Drift Pipe Upstream Endcap

Proposed change: "dish head" to flat flange

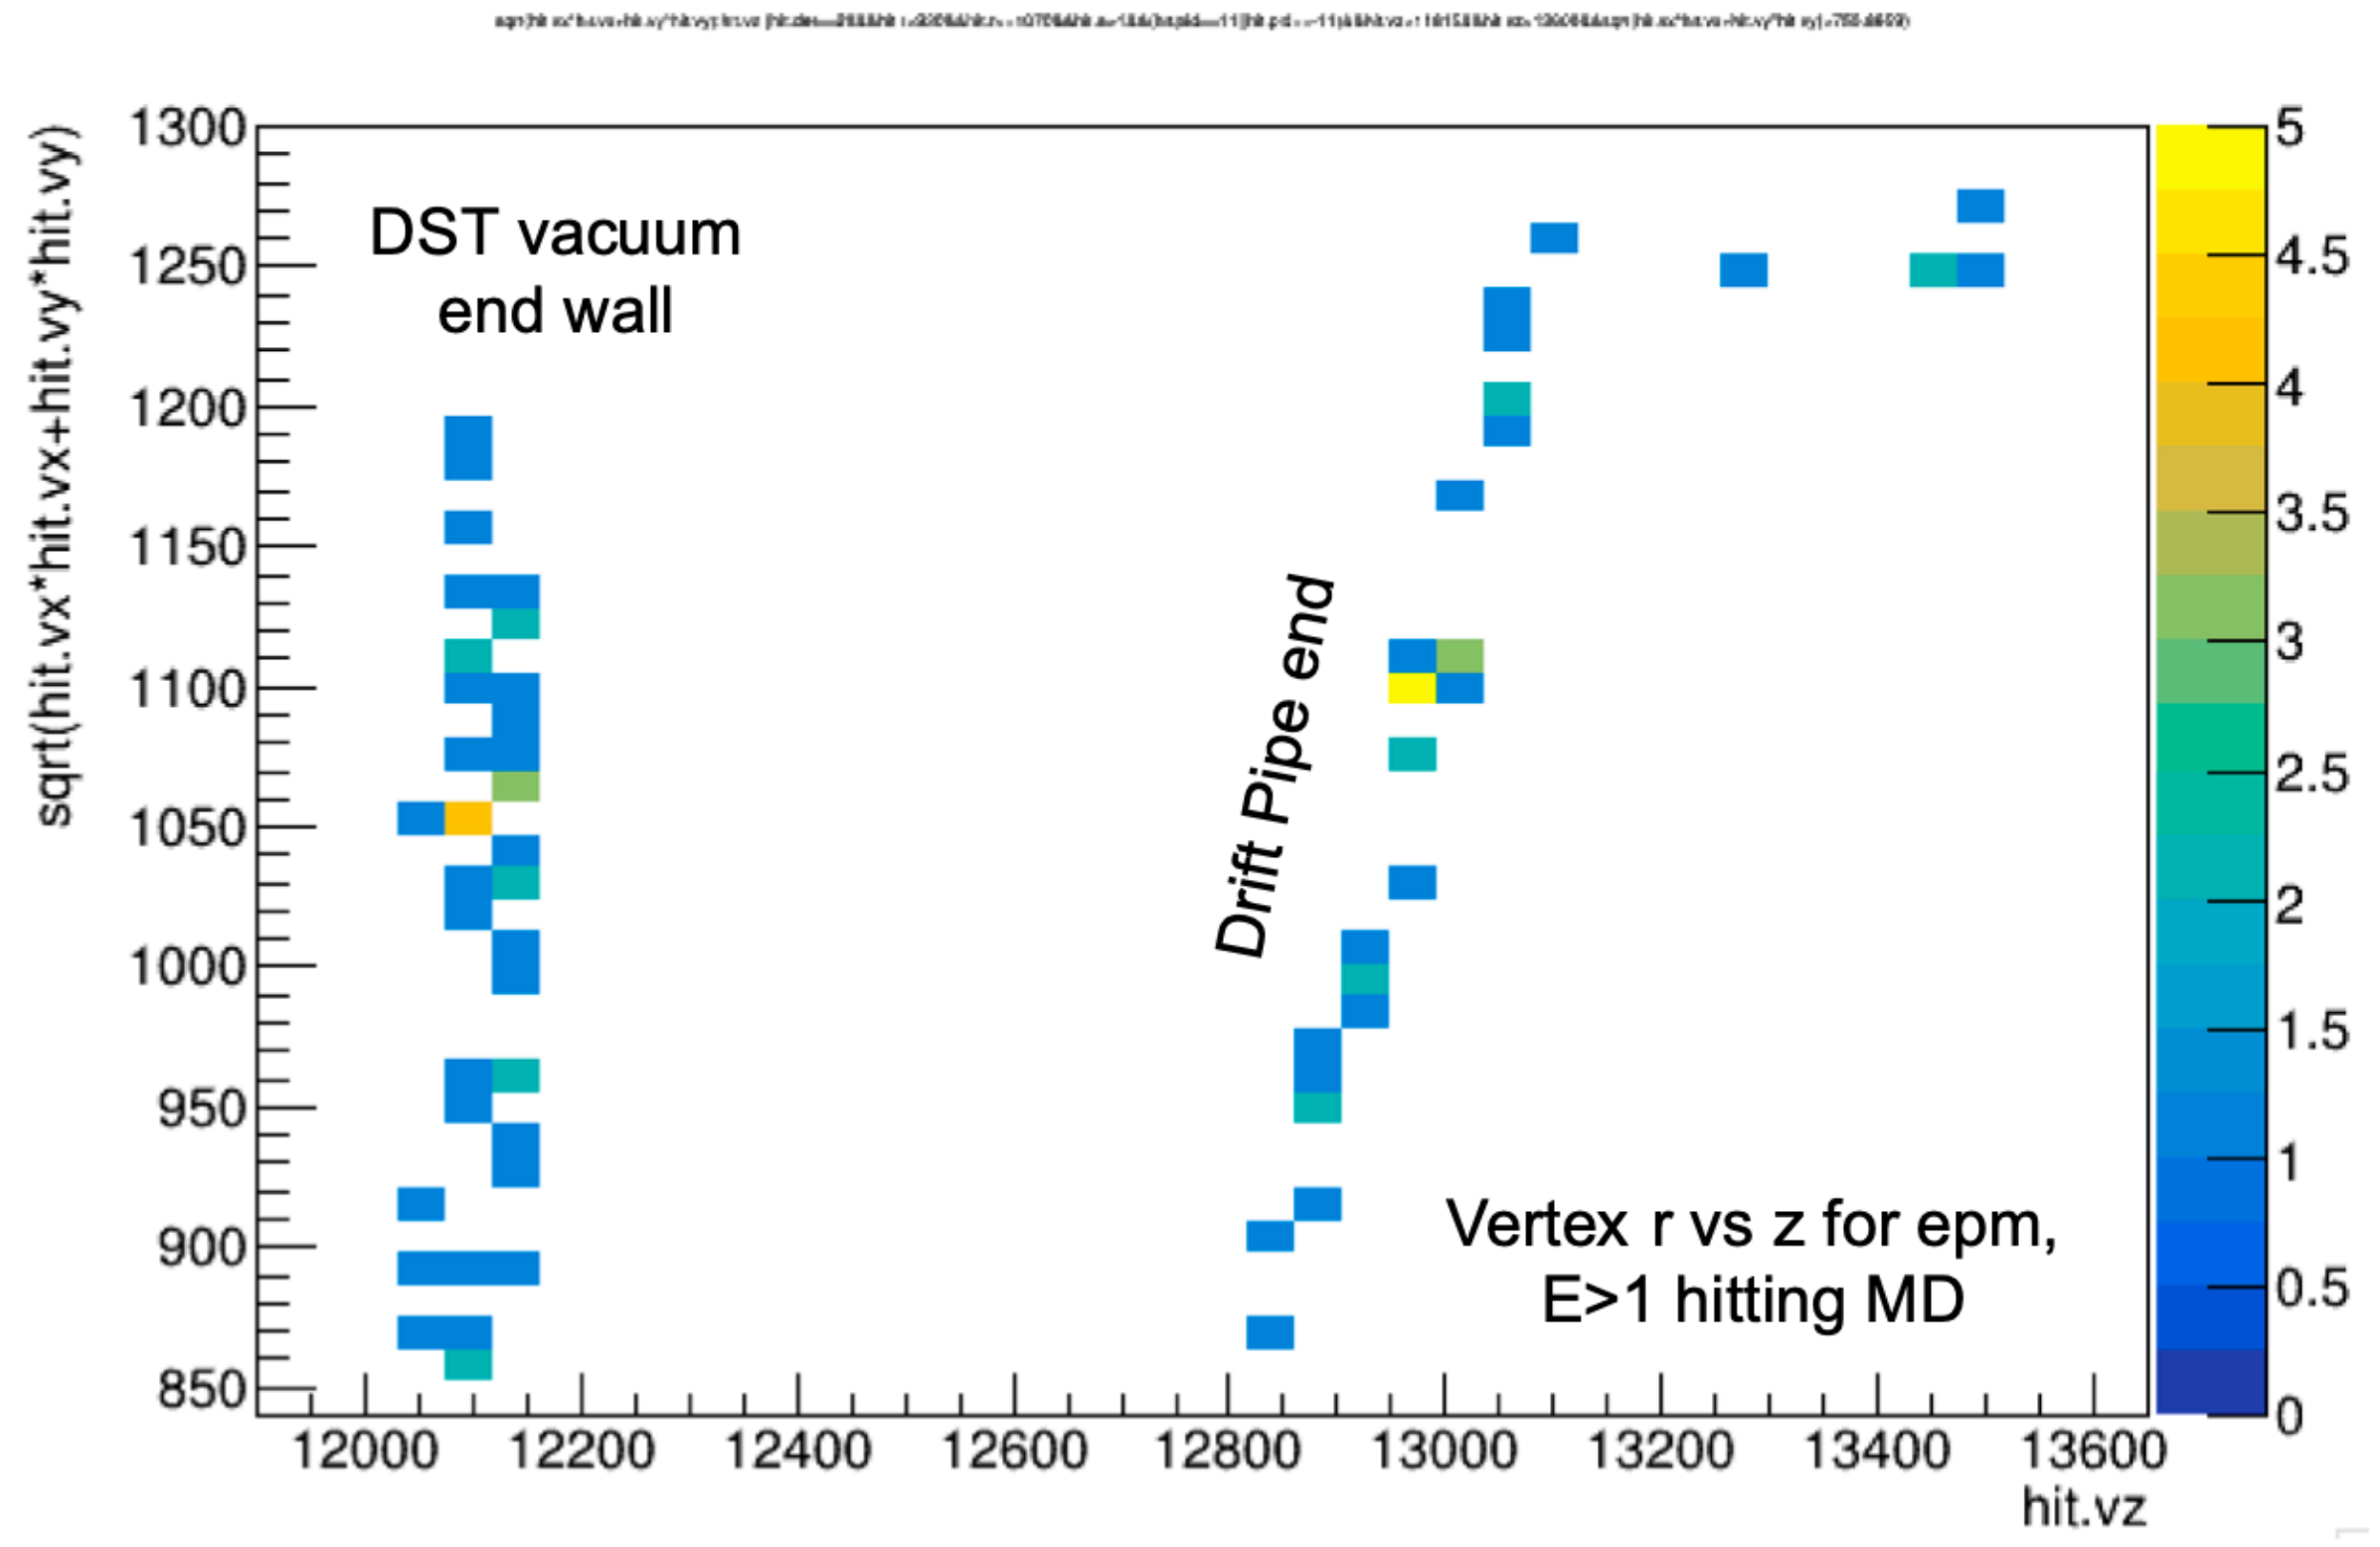
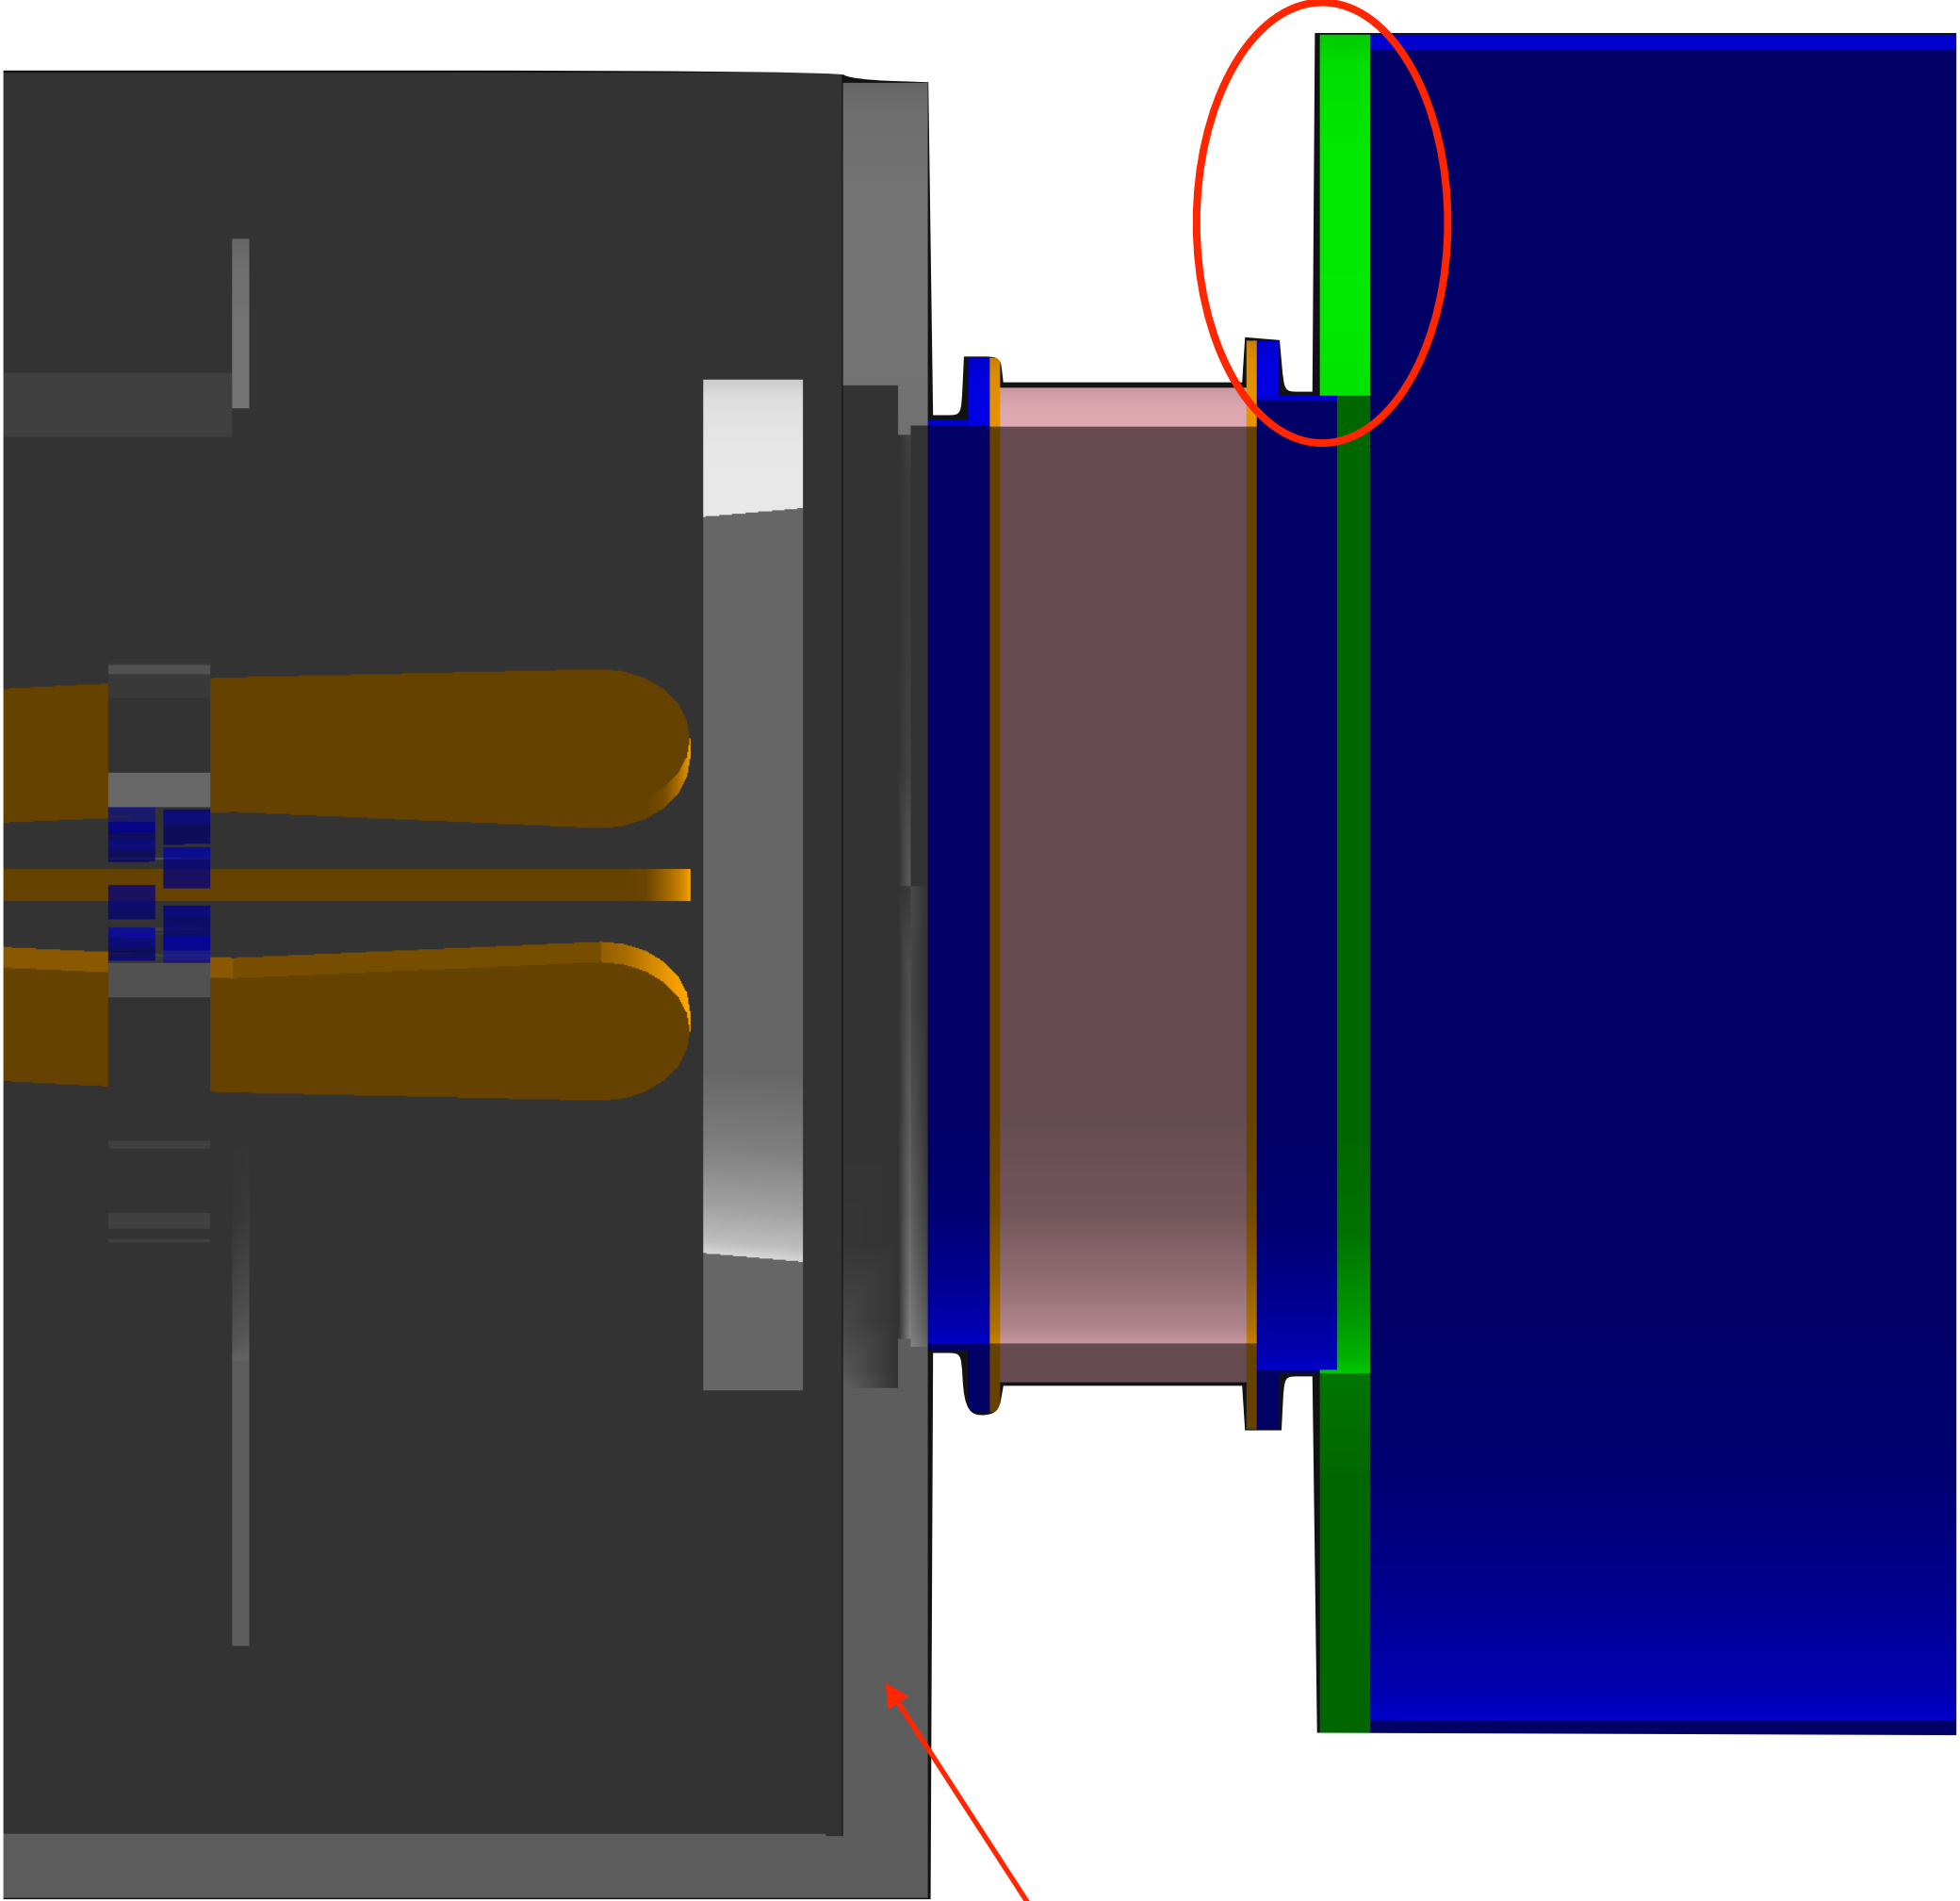
previous design ~1" effective thickness

Already had 5" thick Al wall, for downstream torus vacuum box

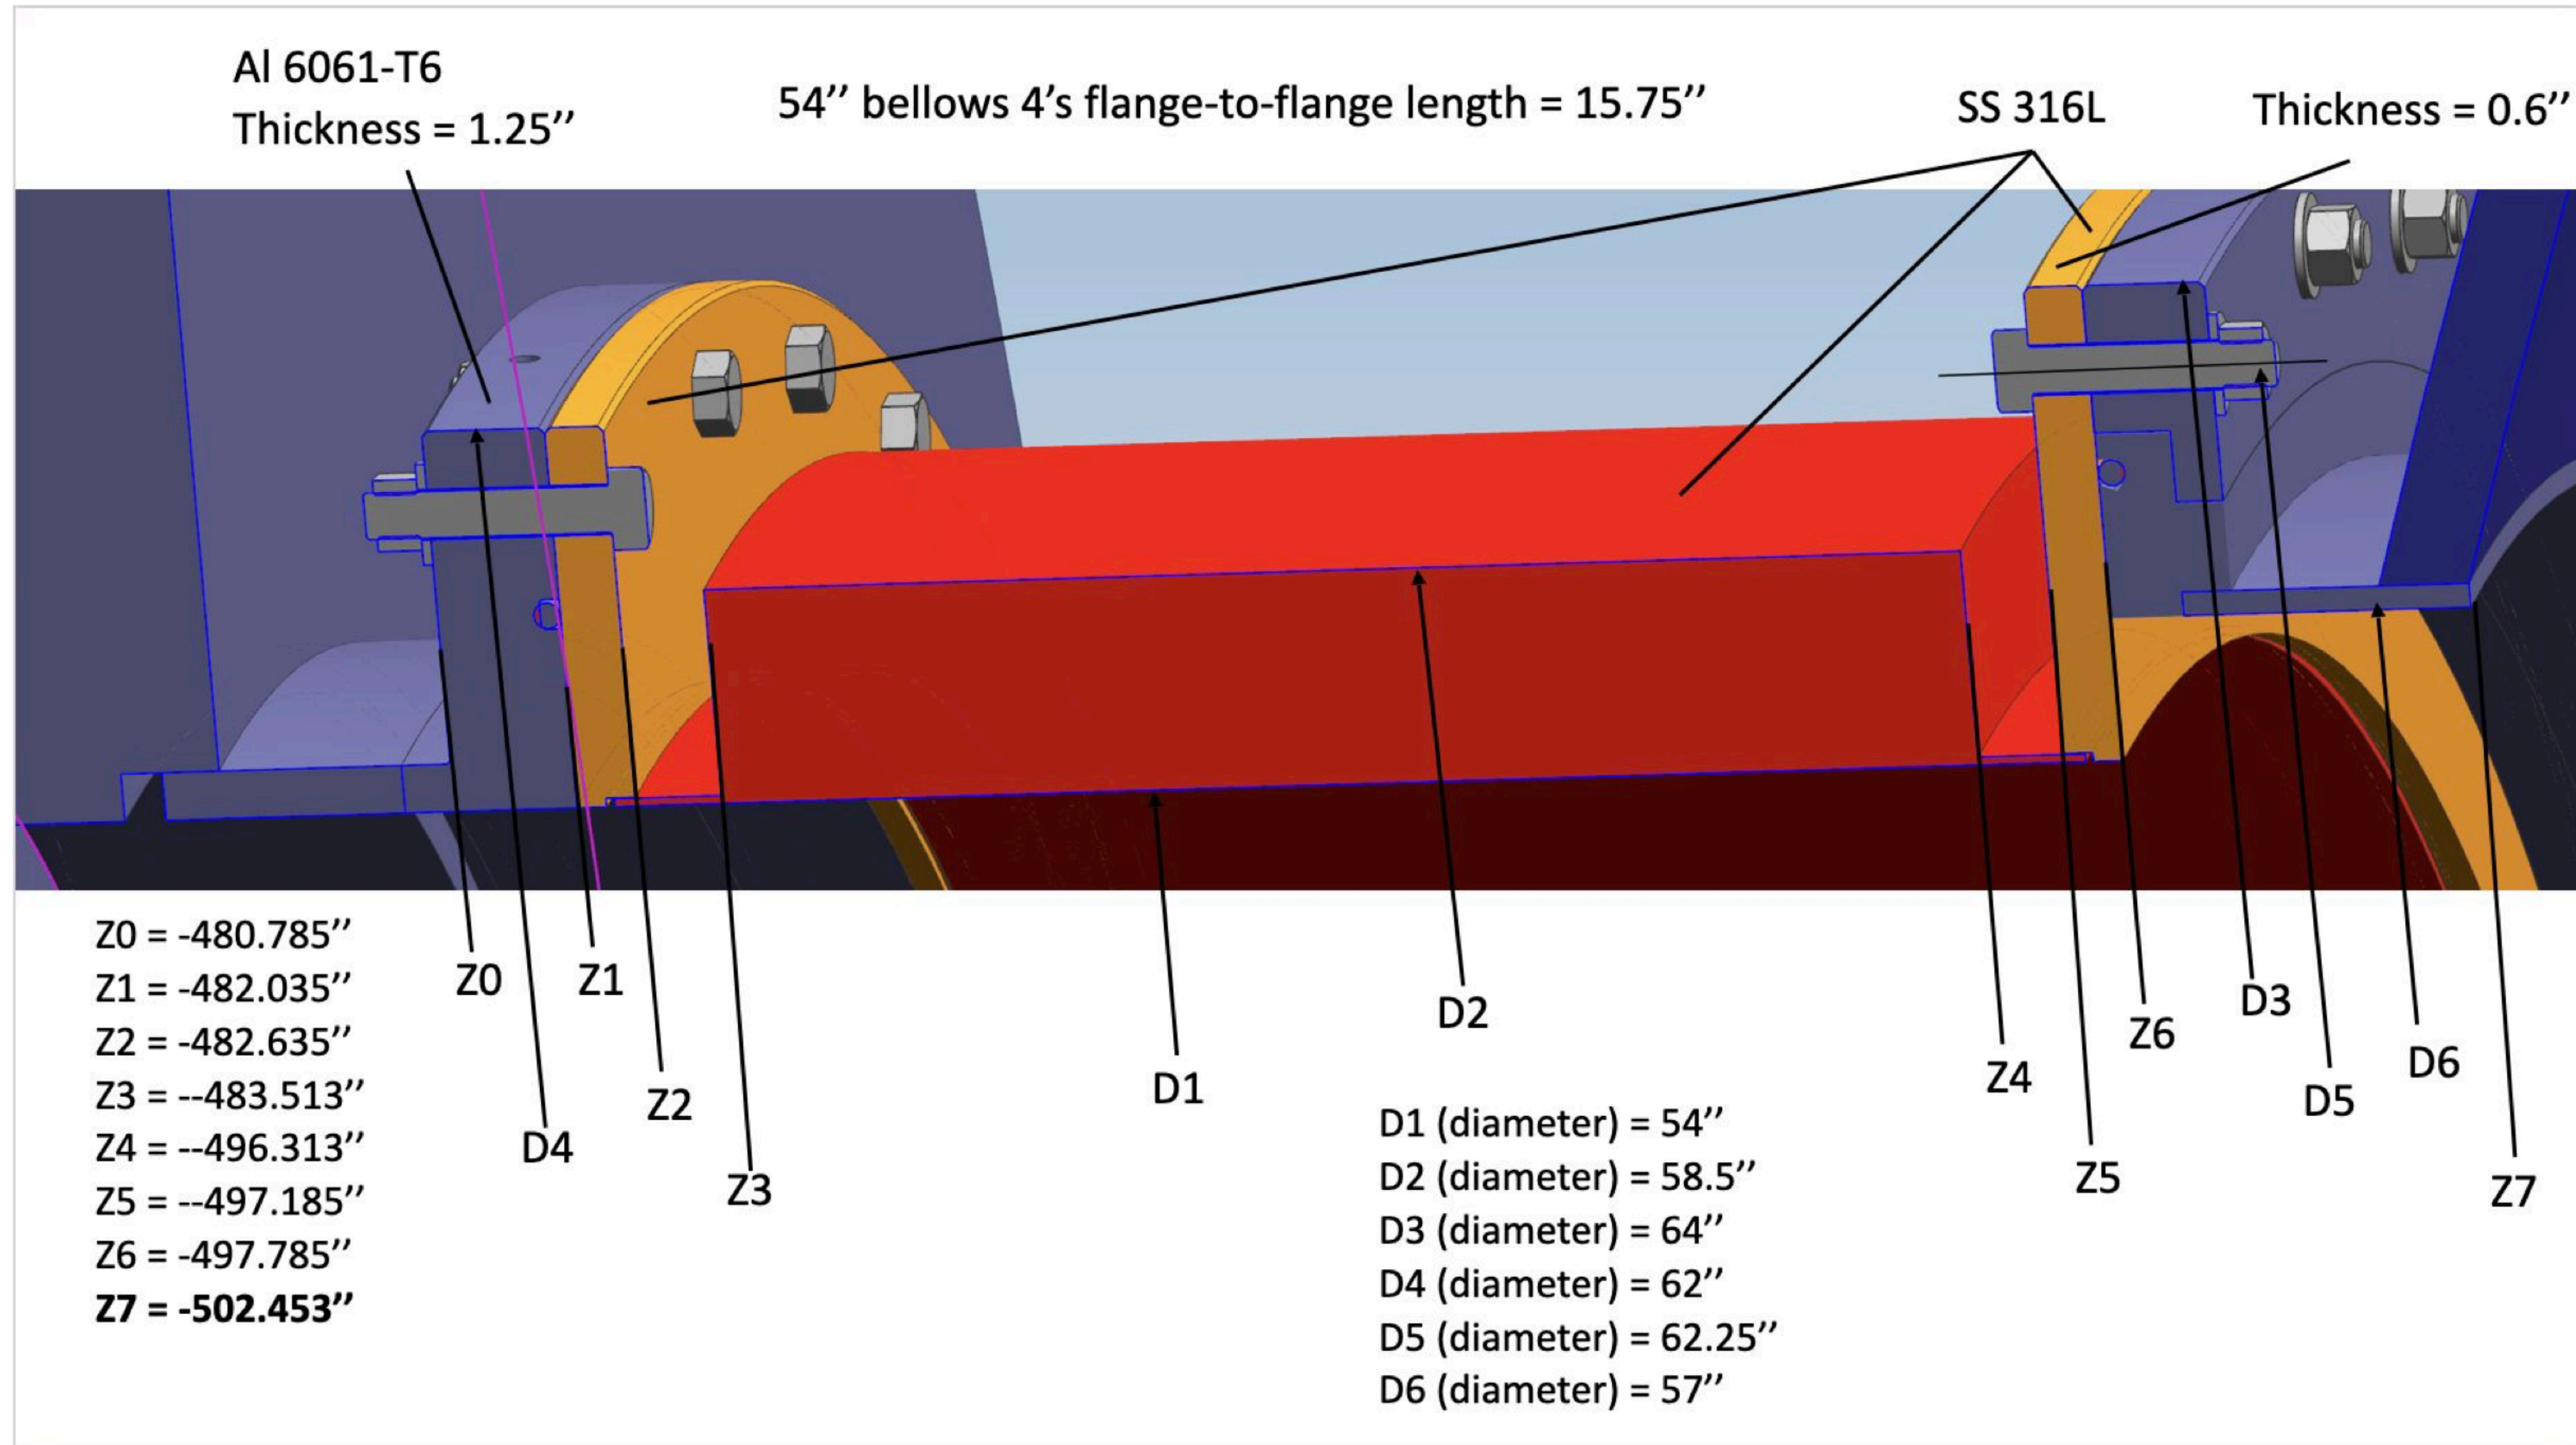
IR expanded to hide connection in Collar 1 shadow

Connection hides in shadow of collar 1
